UNITED STATES PATENT AND TRADEMARK OFFICE

APPLICATION NO.	FILING DATE	FIRST NAMED INVENTOR	ATTORNEY DOCKET NO.	CONFIRMATION NO.
10/661,287	09/12/2003	Feng Chen	TI-35766 (032350.B524)	7460
23494	7590	11/24/2004	EXAMINER	
TEXAS INSTRUMENTS INCORPORATED P O BOX 655474, M/S 3999 DALLAS, TX 75265			WILLIAMS, HOWARD L	
			ART UNIT	PAPER NUMBER
			2819

Office Action Summary	Application No.		Applicant(s)	
	10/661,287		CHEN, FENG	
	Examiner		Art Unit	
	Howard L. Williams		2819

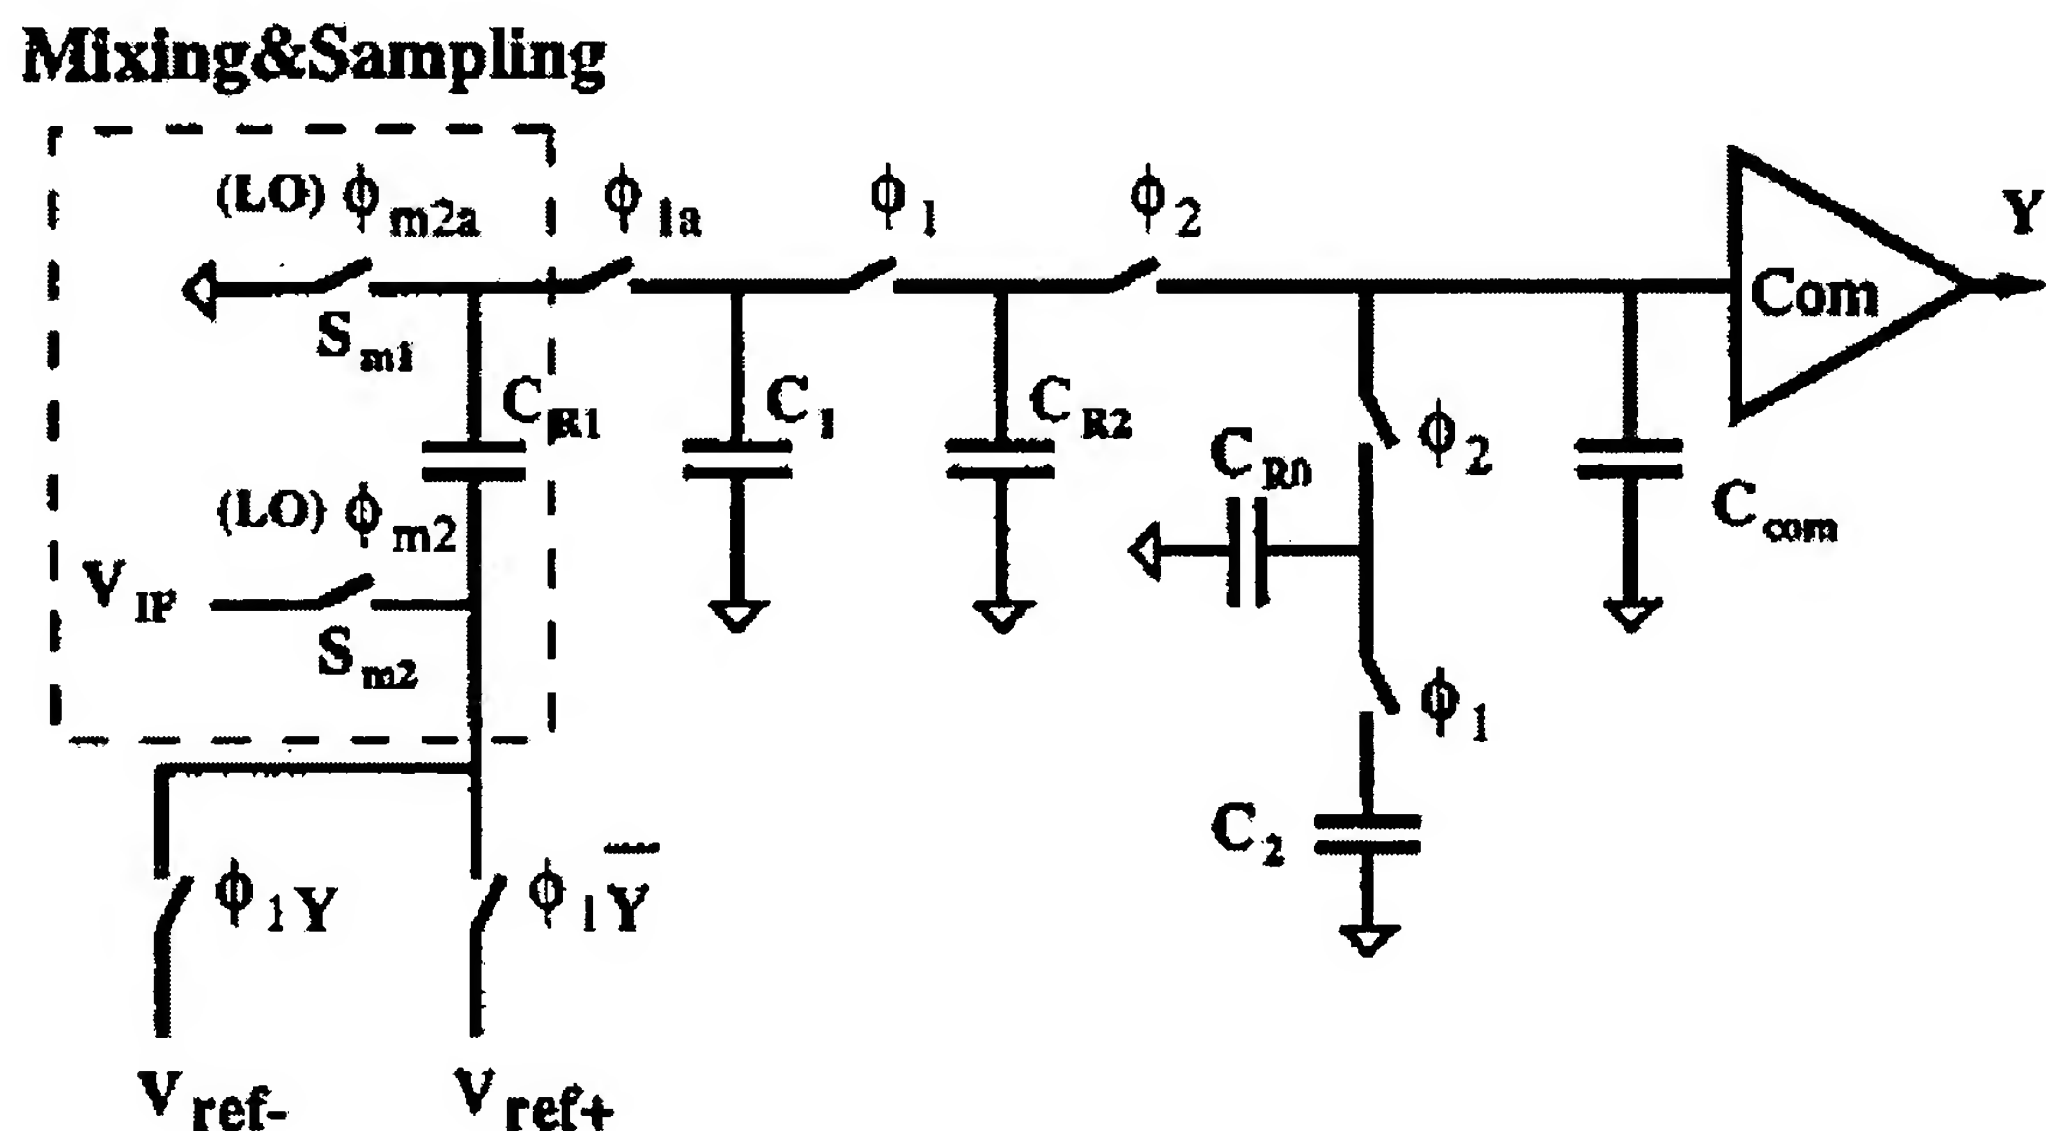
Applicant's arguments filed 13 September 2004 have been fully considered but they are not persuasive. Whether the present applicant is the author of the cited (and applied) Chen article is not particularly relevant. The examiner had assumed that it was someone different because surely applicant has cited relevant art of which he/she is aware. Beyond this the response comments to the examiner's clairvoyance. Ahh, if it were so. In reality Benabe's discloses a passive continuous time delta sigma converter that has passive continuous time forward path filter depicted in figure 3. The Chen article provides in figure 2:

It is also rather interesting that the element C_{R2} and the two switches clocked on Φ_1 and Φ_2 simulate a resistor as well known in switched capacitor technology. Capacitor C_{R0} and its two closest switches function likewise. The choice of subscripts for these two capacitors supports this reading. If one were to redraw the Chen article figure 2 circuit replacing the capacitors C_{R2} , C_{R0} and the adjacent switches one pretty much gets a single line figure 2 of the present application. And with no clairvoyance required. Accordingly the rejection will be maintained.
